MP_09_0153-01-75w submission
Floor plan mark-ups

PROJECT NAME
UTS
DR CHAU CHAK WING
BUILDING
SYDNEY, AUSTRALIA

CONSULTANTS DRAWING NUMBER A8-2.03	
PNO PROJECT NUMBER 02106-09	CONSULTANT PROJECT NO. 2009-022
DRAWN BY YL	CHECKED DB
APP. BY DB	DATE APP. 30 MAY 12
DRAWING STATUS IFC	SHEET SIZE A0
UTS DRG FILE NAME CM1203AP	DRAWING SCALE 1:100
UTS DRG FILE NO. 26813	REV NO. 11

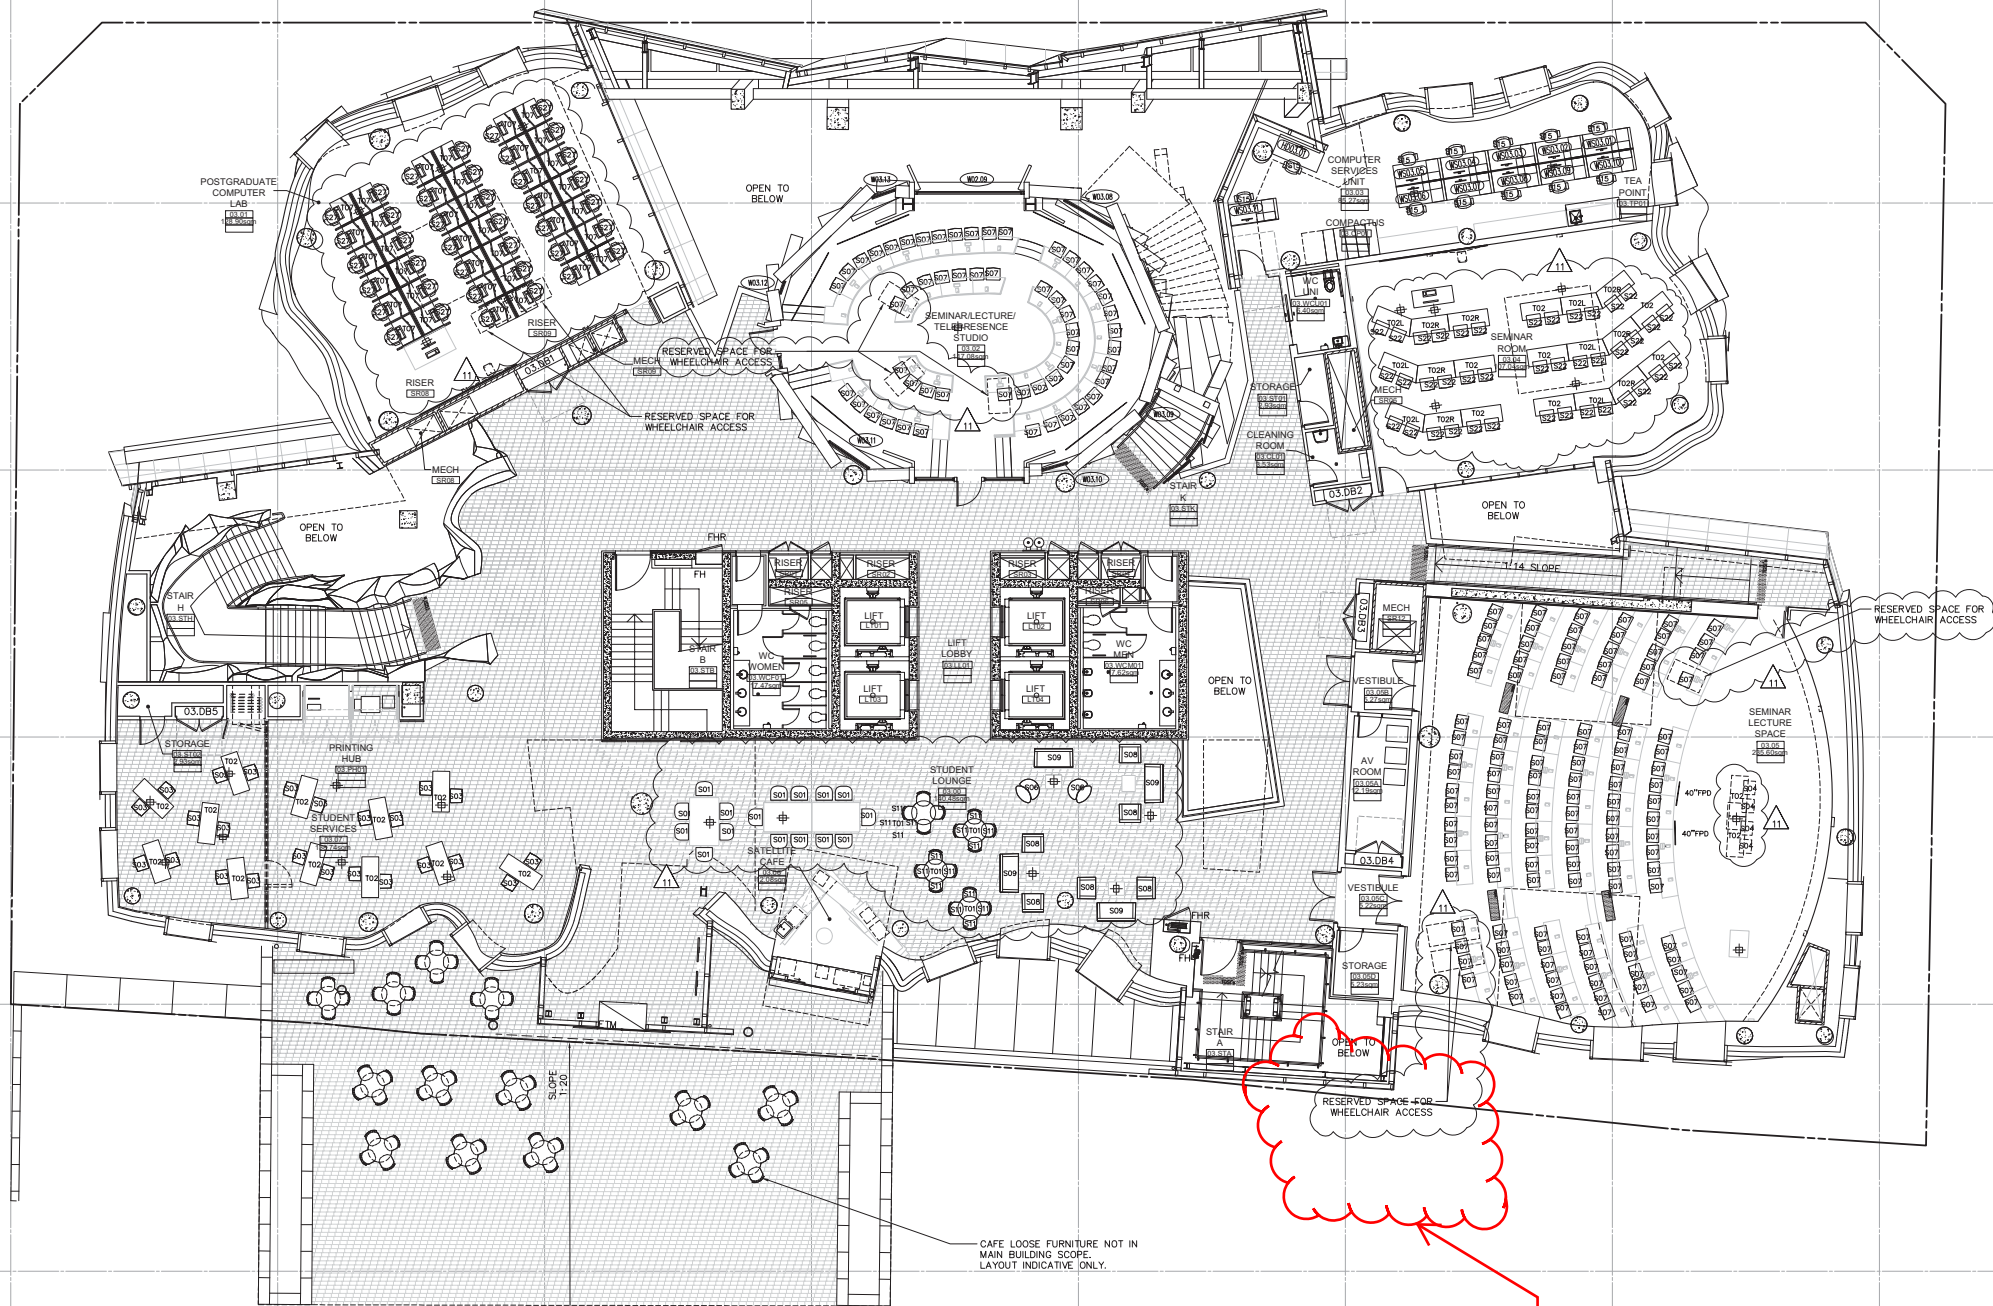
Level 3 - changes to eastern facade
stair

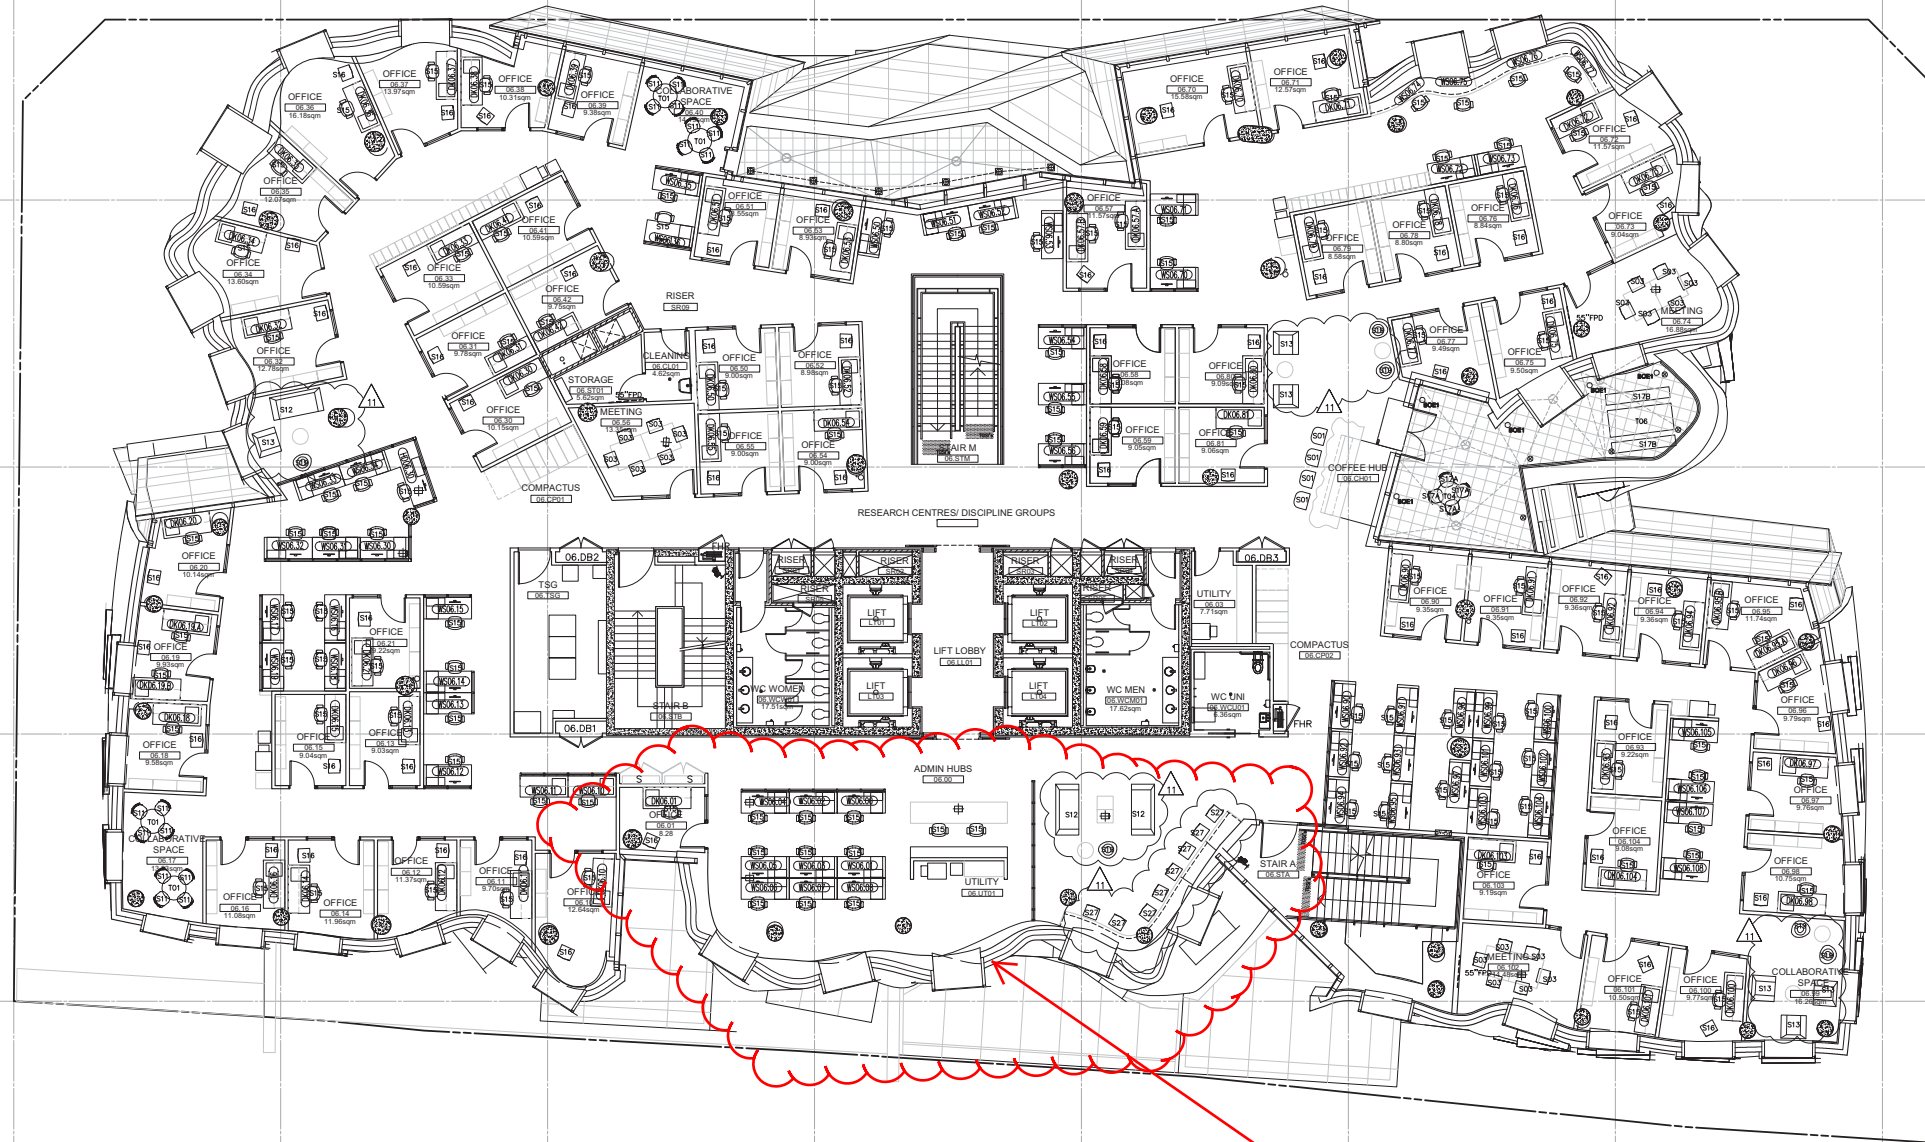
Level 5 - changes to brick geometry
